Access Compliance Report

Public Rights-of-Way

(Curb Ramps)

Intersection ID: 43412	Main Street: PROVIDENCE_CHURCH_LN	Cross Street: PROVIDENCE_RD	Location: NE
ADA ID: C0993B5EC0D2	Ramp Type: Perp	Initial Pass/Fail: Fail	Overall Compliance: No
Severity Score: 22.5			
Codes/Mitigation Info/Possible Solution		Field Measurements/Component Compliance

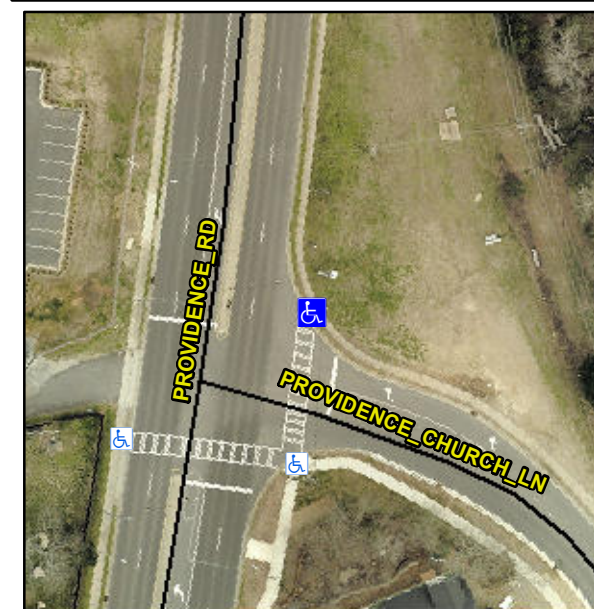
Not Found, R304.5.1, R304.2.2, R304.5.3

Compliance	Description	Data	Compliance	Description	Data
N/A	Ramp Length (in)	85.0	No	Ramp Slope (%)	9.0
No	Ramp Width (in)	44.5	No	Ramp XSlope (%)	4.1
N/A	Flare Type LT	N/A	N/A	Flare Type RT	N/A
N/A	Flare Slope LT (%)	N/A	N/A	Flare Slope RT (%)	N/A
N/A	Flare Traversable LT?	N/A	N/A	Flare Traversable RT?	N/A
N/A	Landing Length (in)	N/A	N/A	DWS Provided?	N/A
N/A	Landing Width (in)	N/A	N/A	DWS Contrast?	N/A
N/A	Landing Slope (%)	N/A	N/A	DWS Length (in)	N/A
N/A	Landing X Slope (%)	N/A	N/A	DWS Full Width?	N/A
N/A	Landing Curb? (Y/N)	N/A	N/A	DWS Offset (in)	N/A
N/A	Shared Landing?	N/A			
N/A	Gutter Ponding?	N/A	N/A	Gutter Slope (%)	N/A
N/A	Gutter Lip Ht (in)	N/A	N/A	Gutter X Slope (%)	N/A
N/A	Painted X Walk1?	Yes	N/A	Painted X Walk2?	N/A
	X Walk 1 Direction	To S		X Walk 2 Direction	N/A
N/A	X Walk 1 Width (in)	97.0	N/A	X Walk 2 Width (in)	N/A
	X Walk 1 Slope (%)	5.1		X Walk 2 Slope (%)	N/A
	X Walk 1 X Slope (%)	1.9		X Walk 2 X Slope (%)	N/A

Remove & Replace Entire Ramp.
